## DRAWINGS

# Replacement Sheet

Stage I

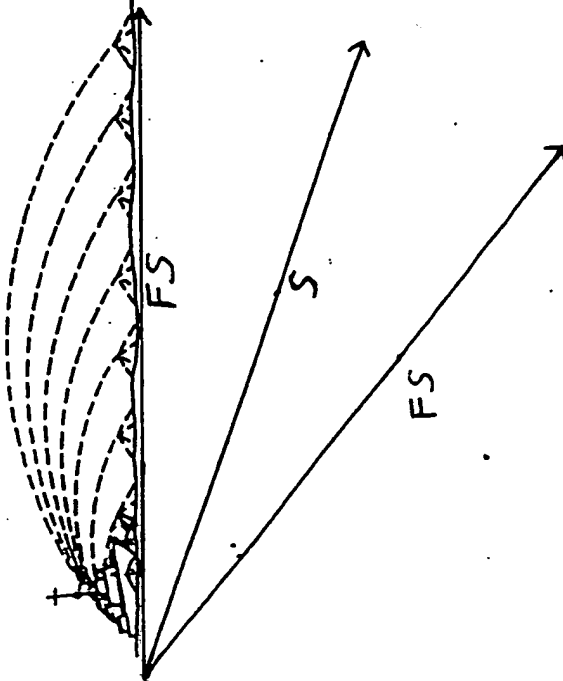
The Patent Office objects to the drawings filed, because they fail to show the deployment of the invention (Figure 1, Stage 1), which states that the invention is deployed from the aft deck of a ship (page 5, lines 6-7), as described in the specification. In response, Applicants have corrected Figure 1, Stage 1 by aligning the ship to show deployment from the aft deck of the ship, such as is shown in Figure 2 and described in the specification as filed. Corrected Stage 1 of Figure 1 shows devices thrown to distances from the aft deck of a ship from the left launcher location, such as is shown in the top view exploded view of aft deck "P" in Figure 2. As a result, and in connection with the prior explanations provided by Applicants, Applicants assert that corrected Figure 1, Stage 1, shows the deployment of the invention from the aft deck of a ship as described at page 5, lines 6-7, and thus, that replacement Figure 1 is in accordance with 37 C.F.R. § 1.83(a) and MPEP § 6.0802(d).
